TechMemo #04-0004

PRIORITY:	Normal
DATE:	April 5, 2004
TITLE:	AlphaEclipse 3600 Sign Wireway Pinouts Label Correction
ECO REFERENCE:	n/a
PRODUCT(S) AFFECTED:	AlphaEclipse 3600 Signs
SUMMARY:	This document contains the correct AlphaEclipse 3600 sign wireway pinouts label.

Wireway pinouts label

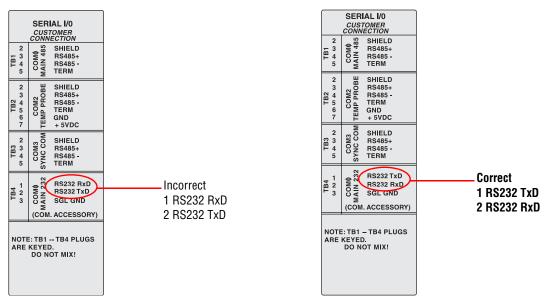
The wireway pinouts label in the AlphaEclipse 3600 sign may be incorrect. For TB4 (Main 232), 1 is actually RS232 TxD and 2 is RS232 RxD.

Pages 21, 22, 24, 25, 26, 27 of the AlphaEclipse Sign Installation Instructions (pn 9711-8001) manual show the incorrect label and will be updated at the next manual release.
